MEMORANDUM

TO: Cassie Younger, Maverik, Inc.
FROM: Stacey Nerger, Senior Planner
DATE: January 3, 2022
SUBJECT: SP21-133 Lincoln Professional Park Filing No. 1 Lot 1 Site Plan

MAVERIK INC. STORE
 LINCOLN AVE. AND DRANSFELDT RD.
 PARKER, CO

3 FUEL DISPENSING CANOPY - BUILDING SIDE ELEVATION
SCALE: 1/4" = 1'-0"

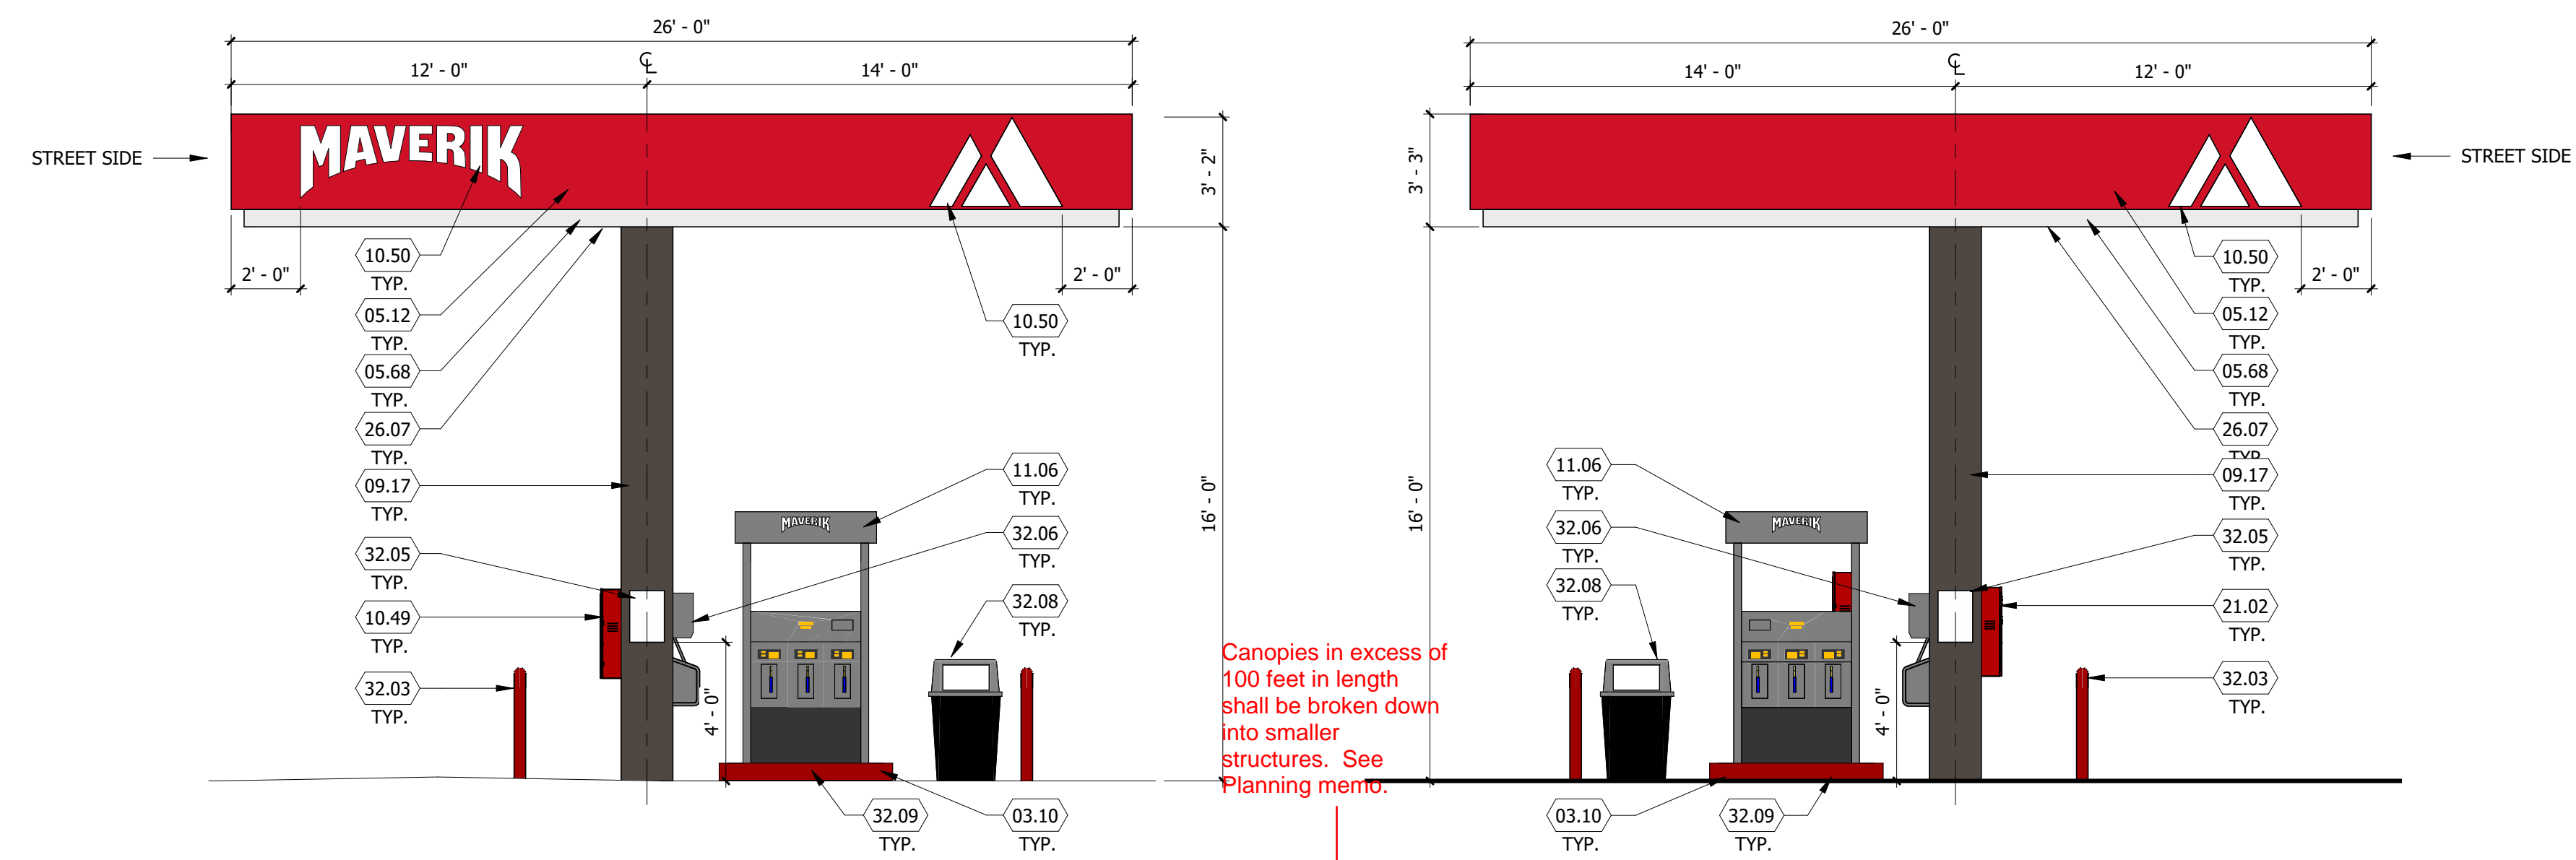
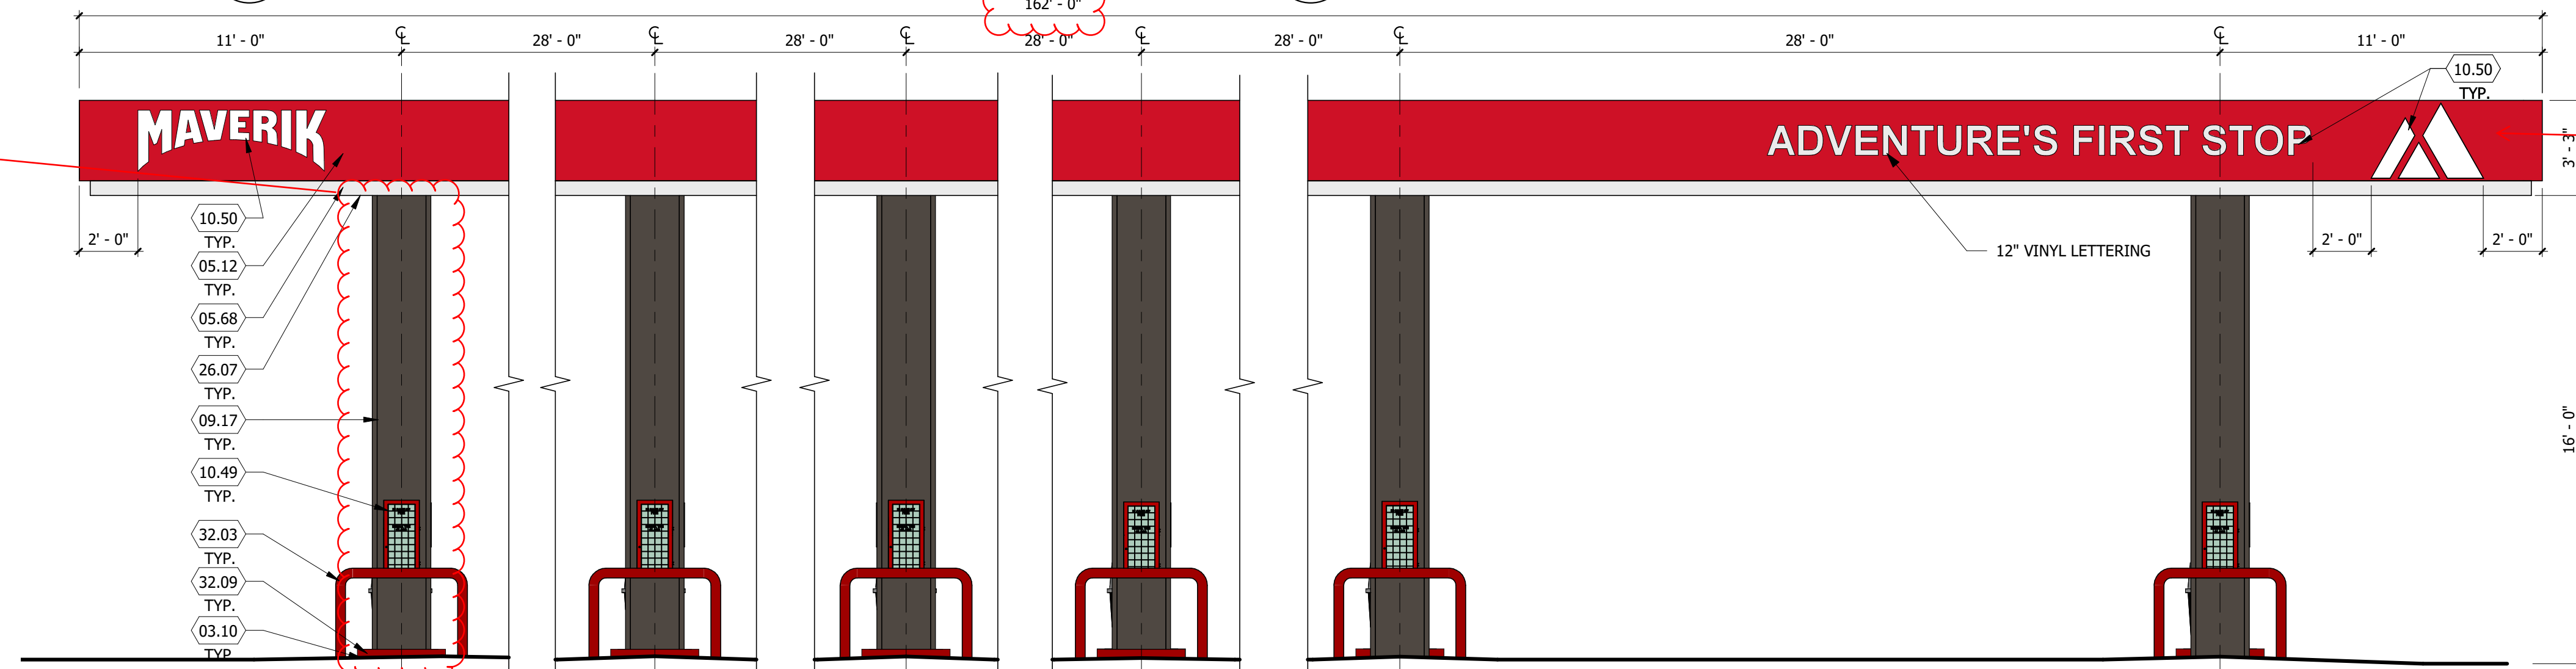
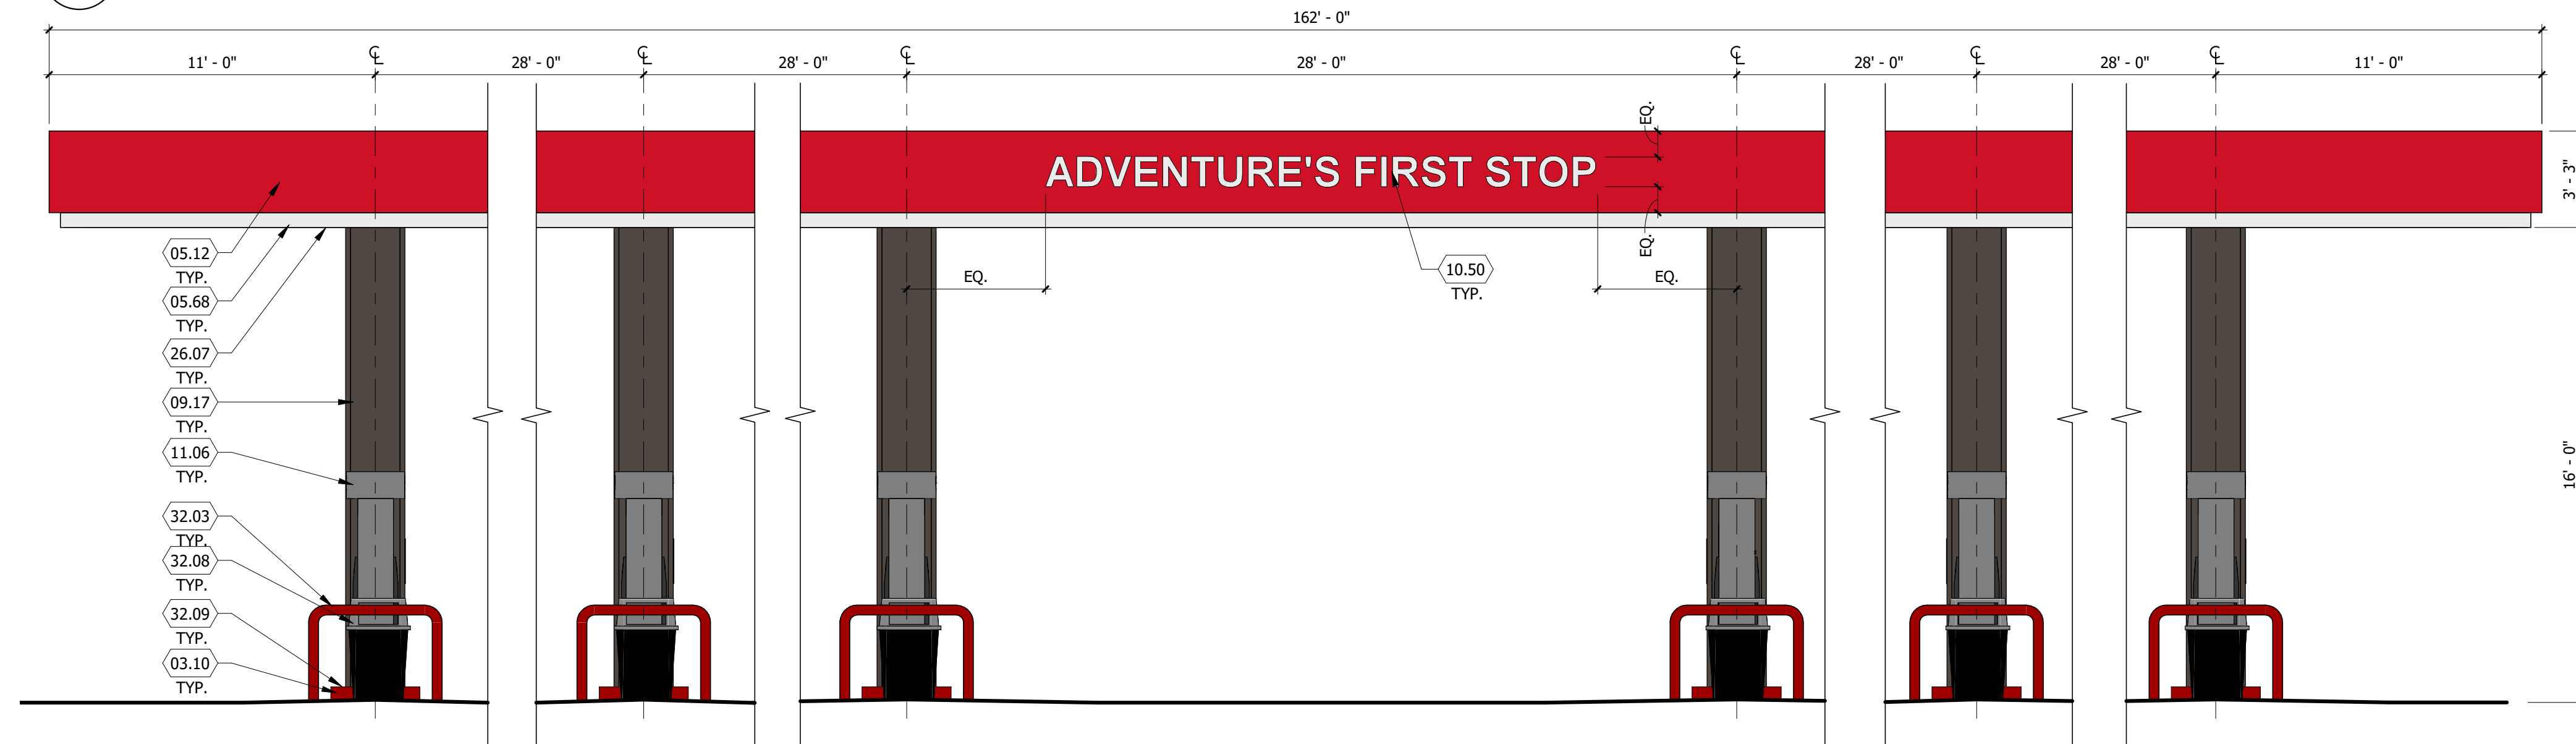
Canopies in excess of 100 feet in length shall be broken down into smaller structures. See Planning memo.

Posts of the canopy should consist of heavier materials similar to those used on the convenience building.

Pursuant to the Design Standards: Intense, bright (for example, a neon color), black, or fluorescent colors are not permitted to be used as the predominant color on any wall or roof. In addition, trademarked corporate/brand color themes may be used as an accent color and shall be limited to two colors in the overall color theme of the building.
